**RE: Young Ranch Resource, LLC; Young Ranch Resource Quarry, M-2021-009
Technical Revision 1**

On behalf of the Young Ranch Resource, LLC and their Young Ranch Resource Quarry ("YRR"), please allow this letter to serve as a request for revision of their 112c Reclamation Permit as Technical Revision 1. This revision updates plans and maps to show the current status and progress of the mining operation within the bounds of the approved permit. All designs, maps, and plans in this revision are in accord with the approved reclamation permit.

Mine Development Phase Stormwater Management Plan

File Name: Young Ranch 231018 C-2 Dev Pad

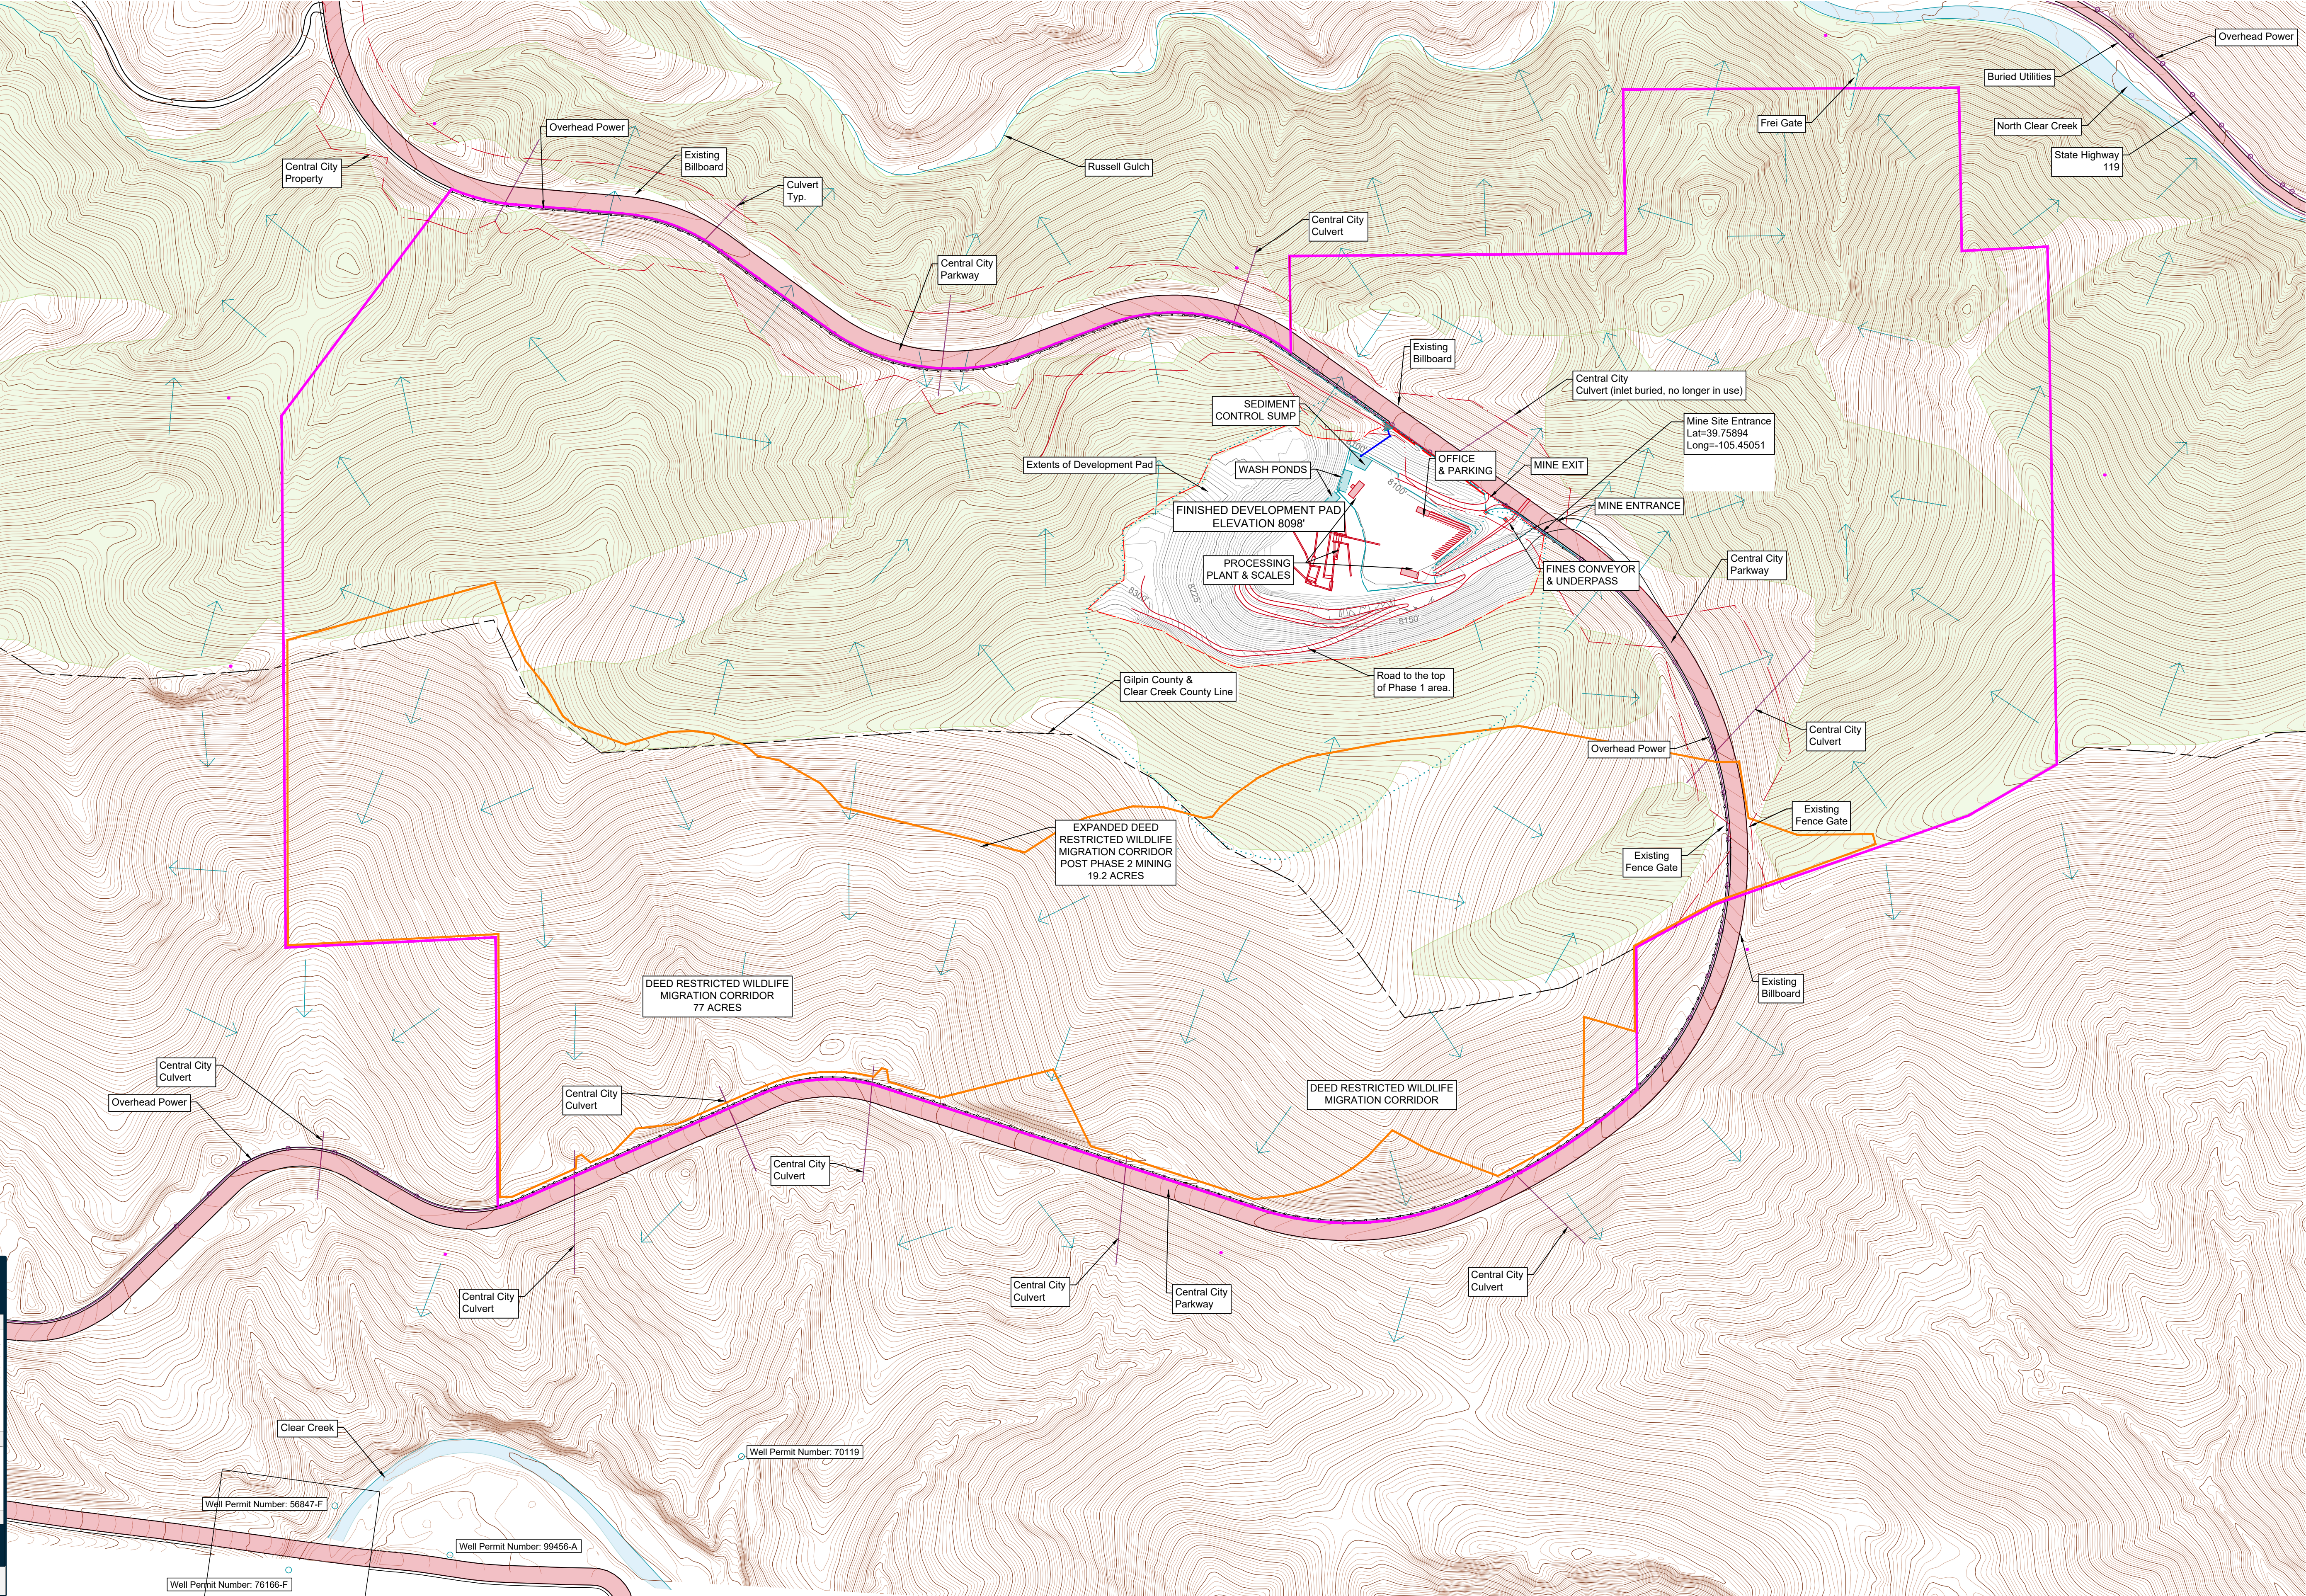
2. Updated Maps C-2 and C-3

Maps C-2 and C-3 are updated to reflect the Development Pad design onsite. Additional maps including C-2A and C-2B are added to the permit via the Stormwater Management Plan. These are included in the attached SWMP.
